NORTHERN BEACHES LOCAL PLANNING PANEL

WEDNESDAY 17 JUNE 2026

4.1 DA2025/1332 - 11 Clavering Road SEAFORTH - Construction of a dwelling house including swimming pool 5

4.2 DA2025/1222 - 13 Clavering Road SEAFORTH - Construction of a dwelling house including swimming pool 117

Image: *Height compliance blanket showing areas of the development that are above the 8.5m height requirement.*

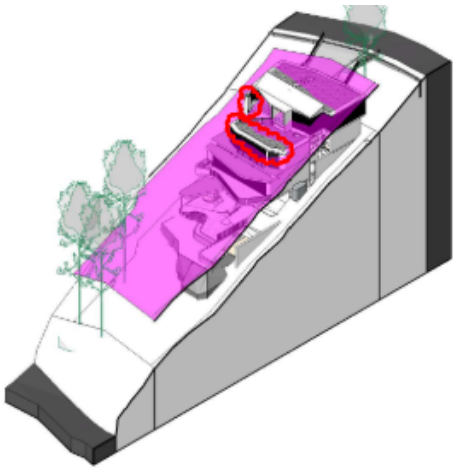
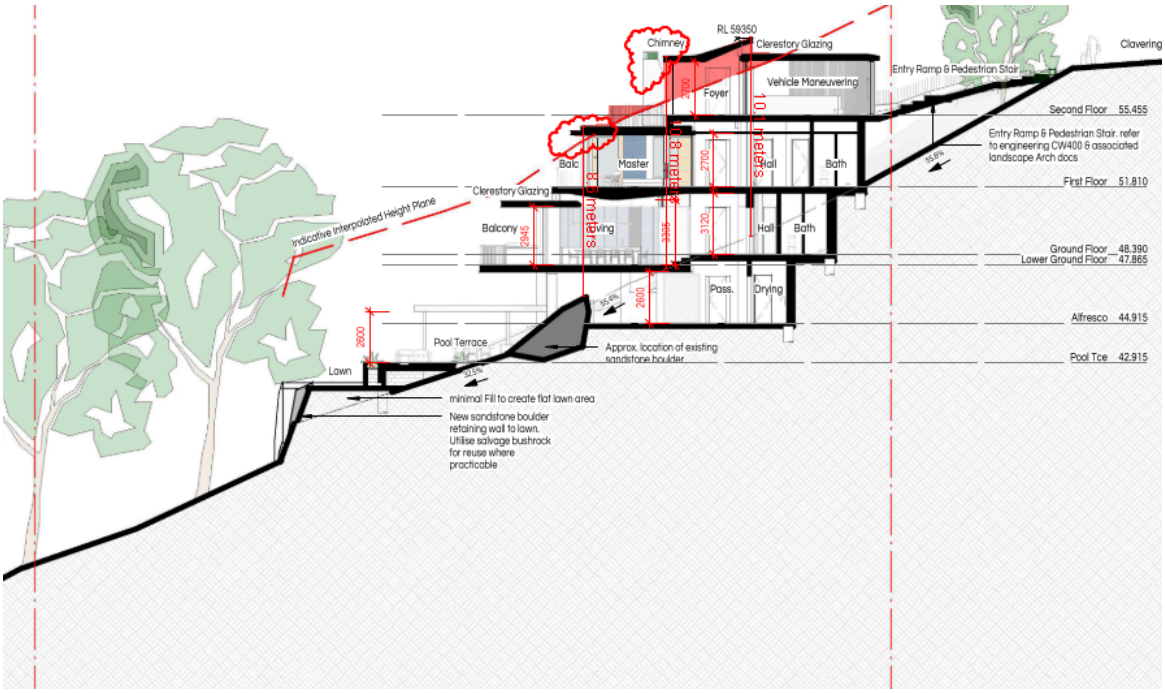
Development standard: Clause 4.3 height of buildings
Requirement: 8.5m
Proposed: 10.36m
Percentage of variation: 21.88%

Image: *Long section showing the building height non-compliance highlighted in red.*

Image: *North elevation - wall height requirement line shown in red.*

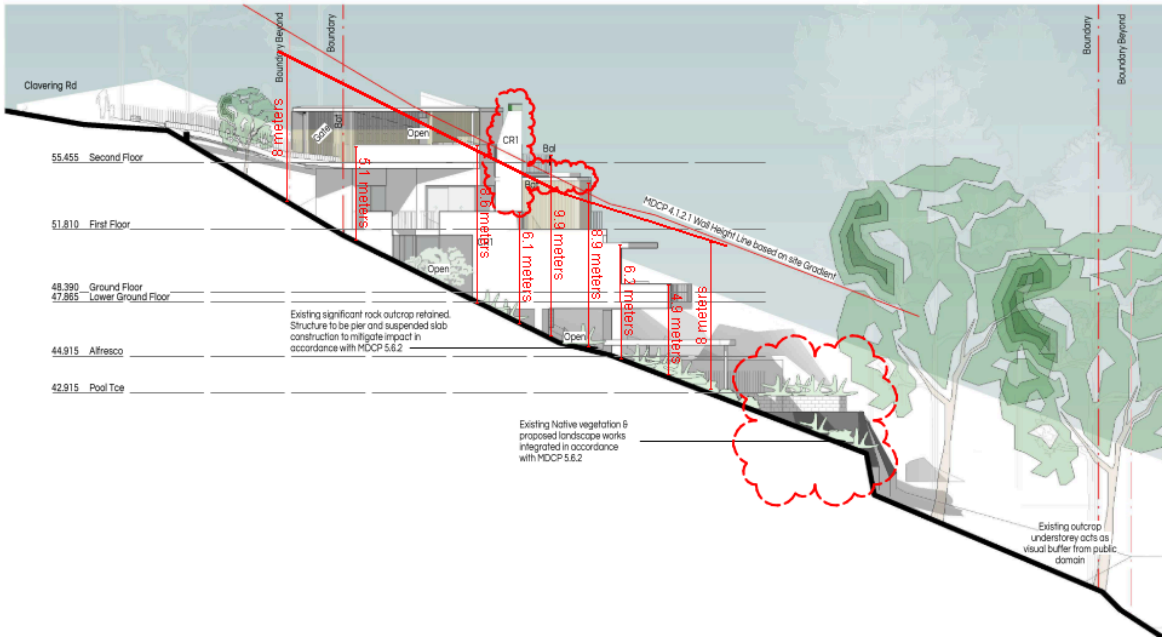
Buildings on the site are not to exceed 2 storeys. The application proposes 4 stories which does not mee the requirement of clause 4.1.2.2 Number of Storeys.

Image: *Site layout*

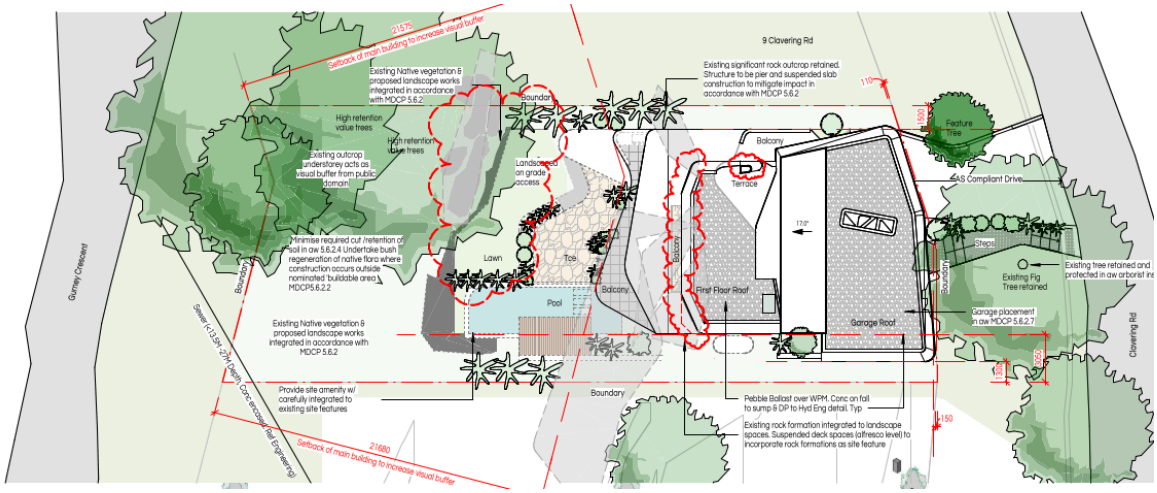
The clause requires a minimum 6 m front setback where neighbouring properties have variable street-facing building lines and no clear prevailing building line is established in the immediate vicinity. Clause 5.6.2 Gurney Crescent and Clavering Road of the MDCP requires structures to be located within a buildable area to protect the natural features of the site. The buildable area is from the front eastern boundary, along the north and south side boundaries to the rock outcrop that runs through the middle of the site. The site and surrounding properties are vacant blocks. The application proposes a minimum front setback of nil to the garage and 7m to the dwelling.

Image: Buildable area cross hatched.

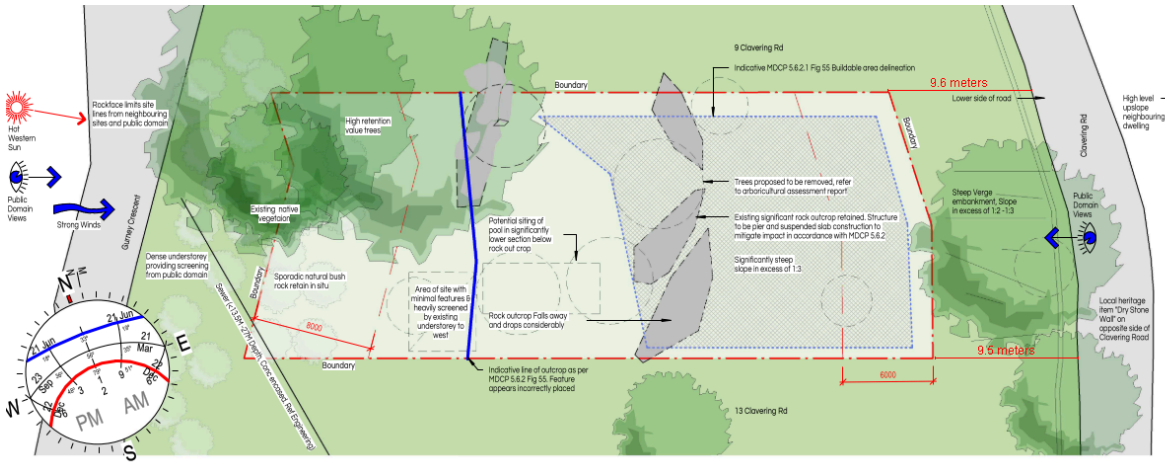
Clause 5.6.2.1 Buildable Area requires dwellings and associated structures, including swimming pools to be generally located within the buildable area as shown on Figure 55. Exceptions are only considered when the objectives of the control are meet.

The proposed swimming pool is located outside of the buildable area.

Image 1: *Height compliance blanket showing areas of the development that are above the 8.5m height requirement.*

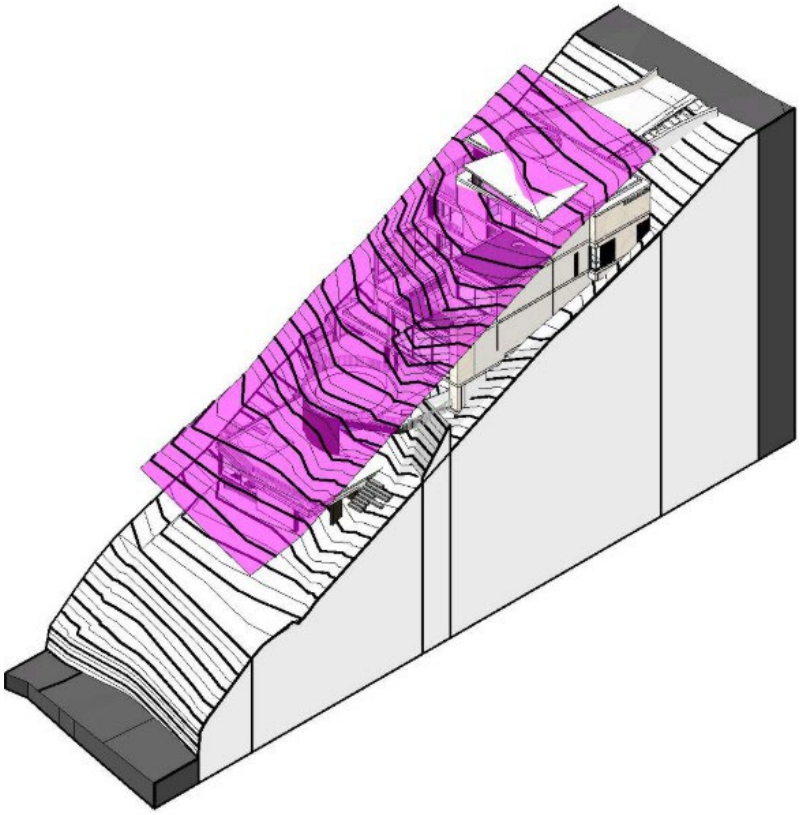
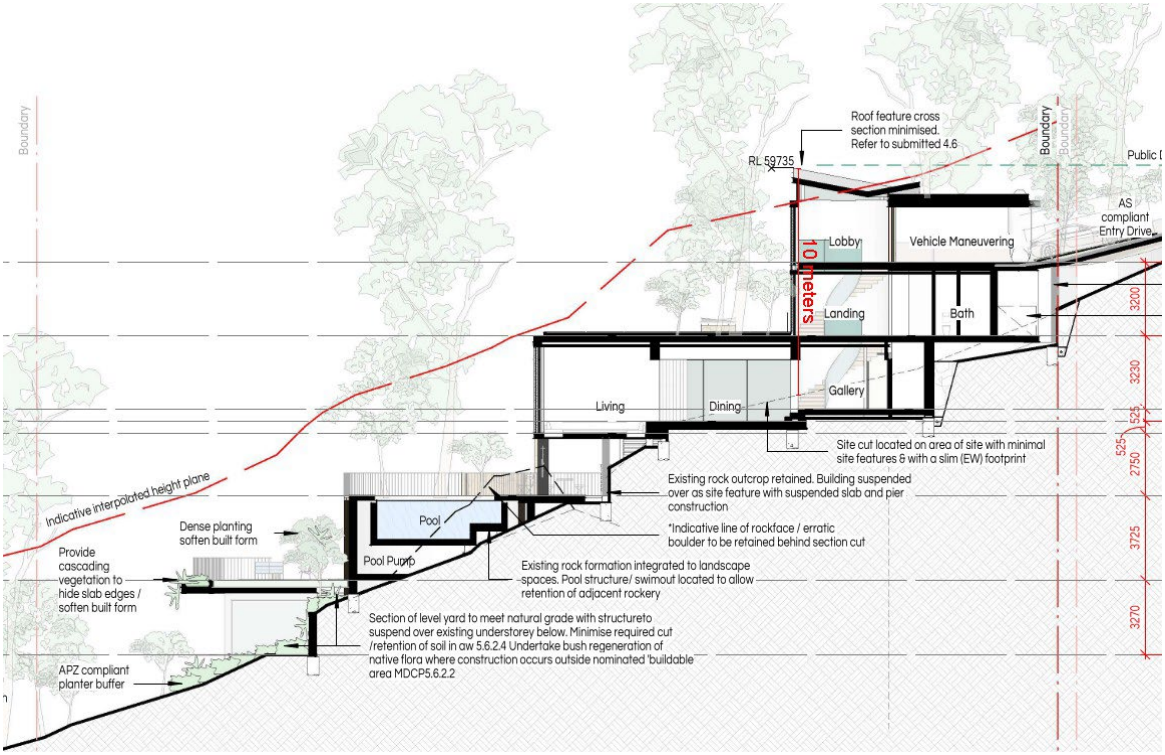
Development standard: Clause 4.3 Height of buildings
Requirement: 8.5m
Proposed: 10.1m
Percentage of variation: 18.8%

Image: *South elevation - Wall height requirement line shown in red.*

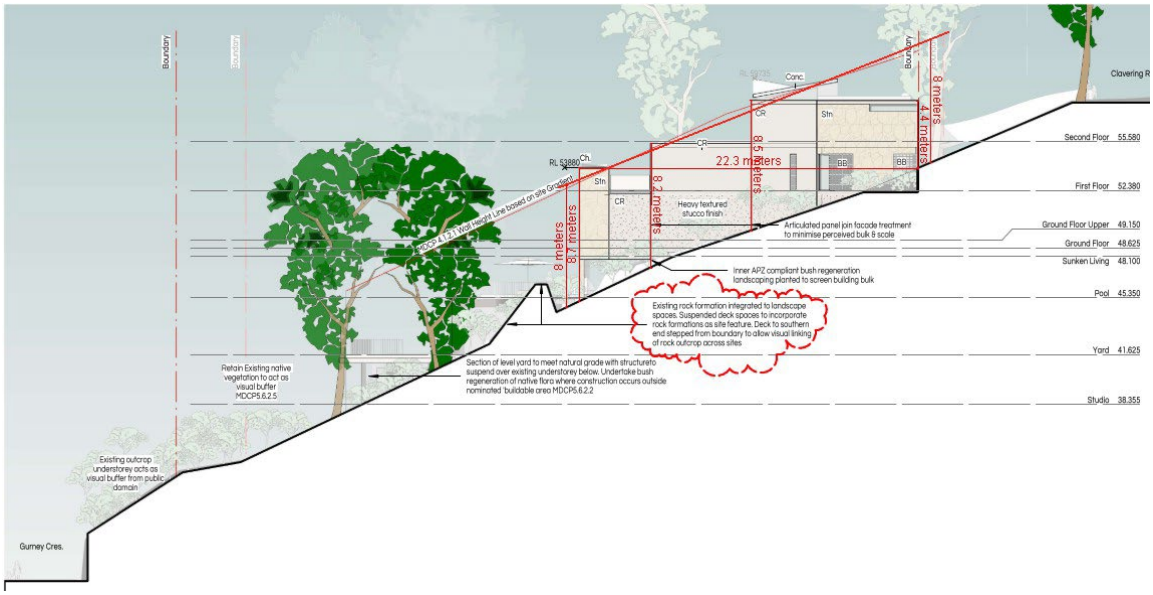
Buildings on the site are not to exceed 2 storeys. The application proposes 3 stories which does not mee the requirement of clause 4.1.2.2 Number of Storeys.

Image: Site excavation diagram.

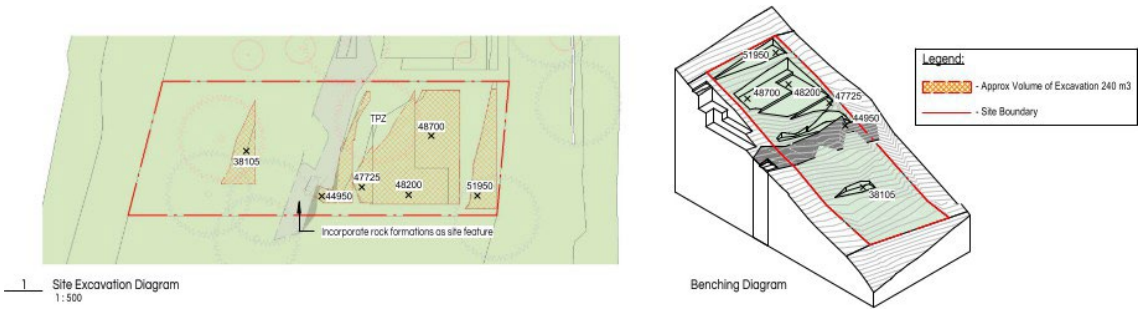
Description of non-compliance
The proposal involves several areas of excavation across the site to accommodate the proposed dwelling. The excavation has a maximum depth of 3.7m, which exceeds the 1m requirement.

Image: *Site analysis plan showing the buildable area of the site shown as a cross hatch.*

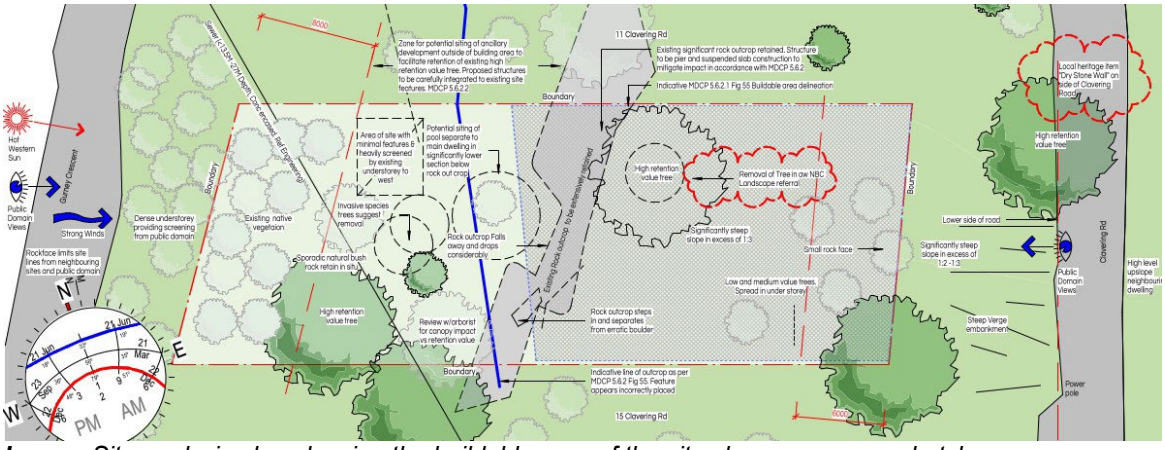
The clause requires dwellings and associated structures, including swimming pools, to be generally located within the 'buildable area' delineated on Figure 55 Gurney Cres 1 and Gurney Cres 2. The proposed swimming pool and studio are located outside of the buildable area.

The clause allows for exceptions to this requirement where the development demonstrates that it meets the objectives, findings and intent of the ERM Study.

Figure 2: *Section showing the portion of the development above the height limit – above the 15.93m bonus height allowance (Housing SEPP) - measured from existing ground level.*

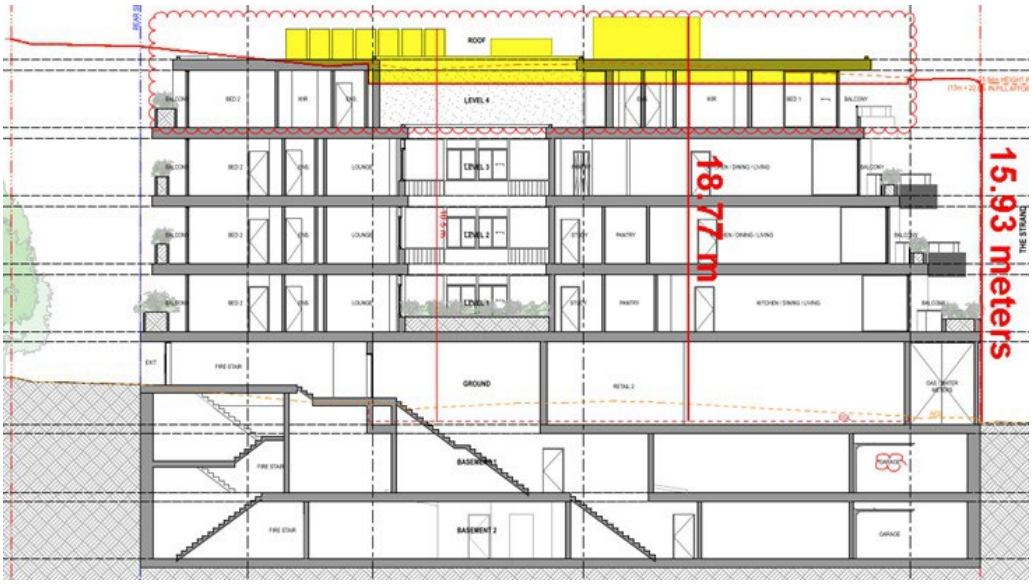
Development Standard: Clause 4.3 of the WLEP and Section 18 of the Housing SEPP
Requirement: 13 metres, increased to 15.93 metres by Section 18 of the Housing SEPP
Proposed: 18.77 metres
Percentage of Variation: 17.83%

Figure 1 - Extract from plans showing street setbacks to the 4th storey to Gladys Avenue and numerically non-compliant portion

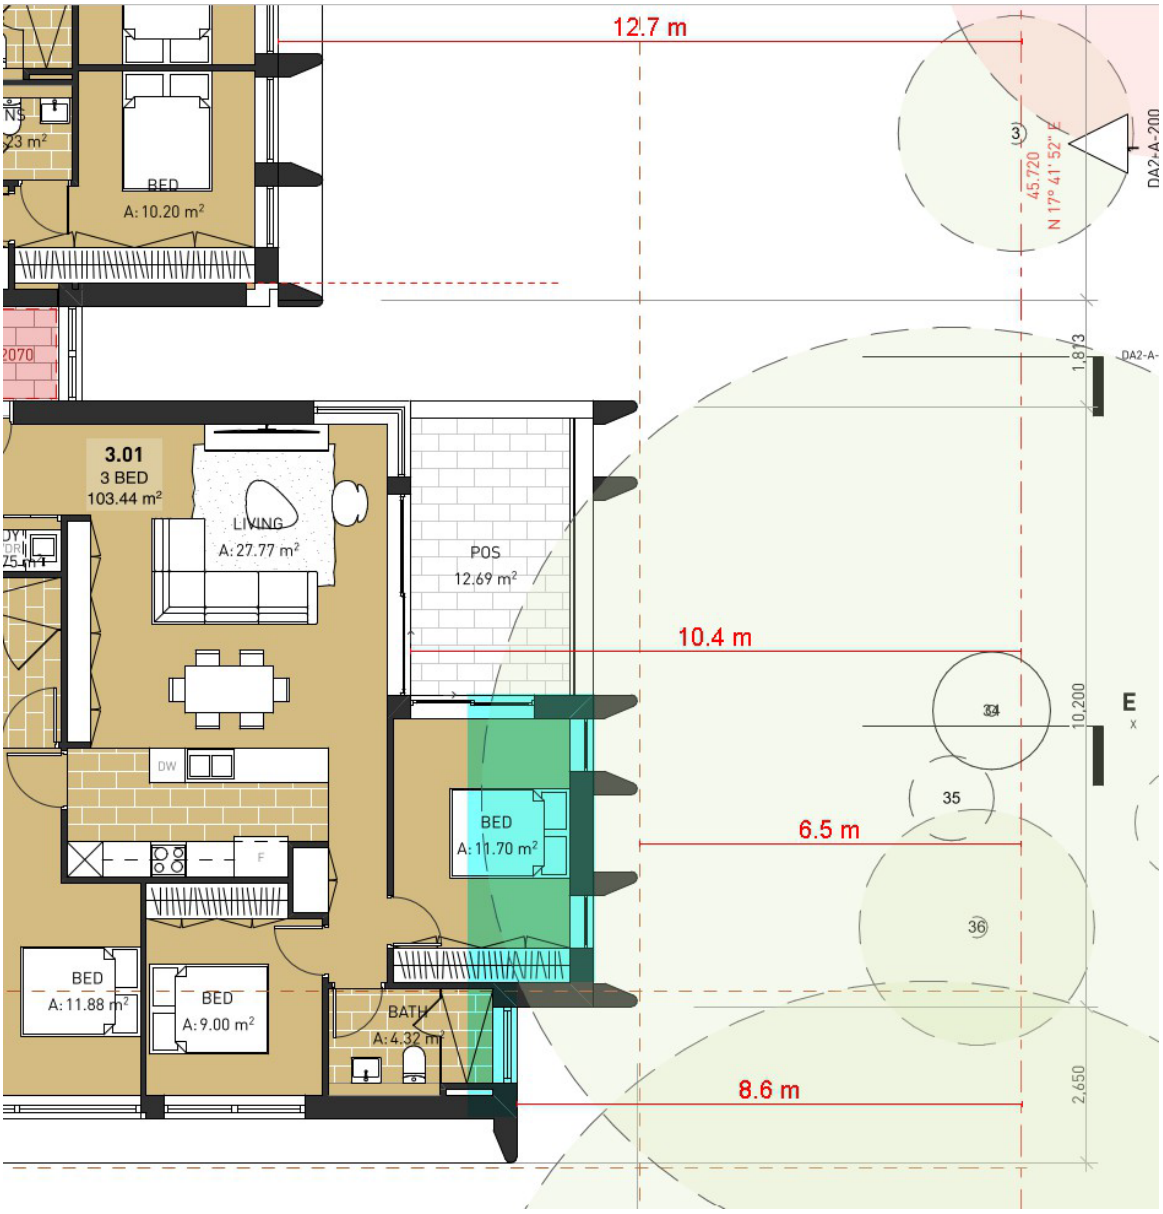
In relation to Requirement No. 3, the fourth floor (Level 3 Plan) facing Gladys Avenue is not setback 3m from the street wall (6.5m at the ground floor) in relation to Unit 3.01 at the southern end of the front facade. Notwithstanding, as identified in the figure below, the non-compliant portion relates to only a minor portion of the eastern bedroom of Unit 3.01 and to a lesser extent the proposed bathroom. All remaining portions of the development are numerically compliant, including the northern portion of the front facade (Unit 3.07) which far exceeds the requirement.

Figure 2 - Extract showing extent of third level within 12m setback

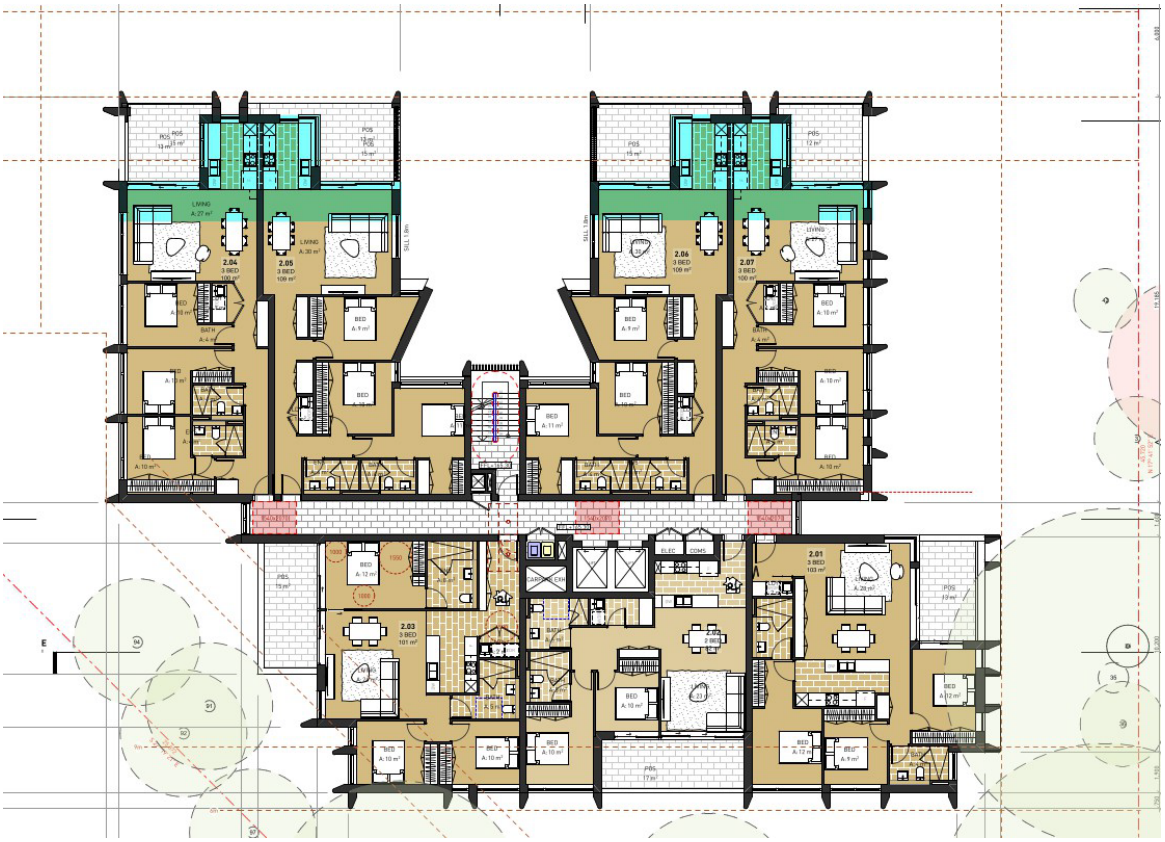
In relation to Requirement No. 4, there are portions of the third, fourth and fifth floors within 12m of the boundary adjoining R2 zoned land to the north. The building is well articulated with varied wall planes and therefore the protruding elements are generally minor in the context of the overall development and length of the northern boundary. The following extracts show those portions of the building:
